# UNITED STATES PATENT AND TRADEMARK OFFICE

APPLICATION NO.	FILING DATE	FIRST NAMED INVENTOR	ATTORNEY DOCKET NO.	CONFIRMATION NO.
09/651,889	08/30/2000	Ritsuko Kawasaki	0756-2205	2171
22204	7590	03/23/2005	EXAMINER	
NIXON PEABODY, LLP 401 9TH STREET, NW SUITE 900 WASHINGTON, DC 20004-2128			FARAHANI, DANA	
			ART UNIT	PAPER NUMBER
			2891

<b>Office Action Summary</b>	<b>Application No.</b>	<b>Applicant(s)</b>	
	09/651,889	KAWASAKI ET AL.	
	<b>Examiner</b>	<b>Art Unit</b>	
	Dana Farahani	2829

**DETAILED ACTION**

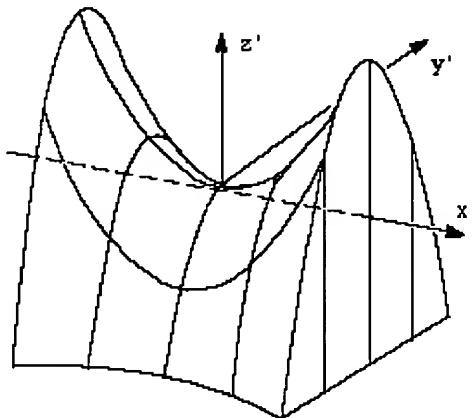
Applicants argue that the Mano reference does not disclose a portion of the channel region 302a concaved shaped in the channel width direction being parallel to a plane of the substrate. However, note that Mano discloses in figures 6a and 6b, that the channel region is

etched in a concave shape (see column 6, line 45). The channel region is obviously a three dimensional object, and the concave portion is not just a single curve line in the channel region 302. Therefore, it cannot be said that the channel region in the reference is only concaved in the length direction. For illustration, the three dimensional picture of a parabola is shown below. Is it correct to say that the parabola is only concaved in length ( $x'$ ) direction, or only in height ( $z'$ ) direction? In fact, it is concaved in both  $x'$  and  $z'$  direction. At least, it can be said that the parabola is concaved in  $x'$  and  $z'$  direction; and is convexed in  $y'$  (width) and  $z'$  direction.

Similarly, the channel region in the Mano reference is convexed in the channel width direction, thereby satisfying the limitation that of the channel region is convexed or concaved in a channel width direction (claims 1-3); convexed in a direction perpendicular to a channel length direction (this direction corresponds to  $z'$  axis in the parabola example) thereby satisfying the limitation that of a portion of the channel region is convexed in a direction perpendicular to a channel length direction (claim 11-12); and convexed in a channel width direction, as stated in claim 13 (this direction corresponds to  $y'$  axis in the parabola example). Moreover,  $x'$  could be said to be the width, and similar to the channel region in the reference, the channel portion 302a is concaved in a channel width direction, which is parallel to an arbitrary plane of the substrate. Note that length is defined by Merriam-Webster's Collegiate Dictionary as an extent in space, and width is defined by the same as a horizontal measurement taken at right angles to the length. All of the curve portions (the concaved and convexed ones that extend in  $x'$  and  $y'$  direction, respectively) of the parabola qualify as a length, since they comply with the definition given above, and therefore, either  $y'$  or  $x'$  could be a width direction, according to how one chooses the length direction. Also, it could be said that the channel forming region is convexed in a direction

perpendicular to a carrier flow direction and is concaved in a direction perpendicular to a carrier flow direction (this direction corresponds to the z' direction).
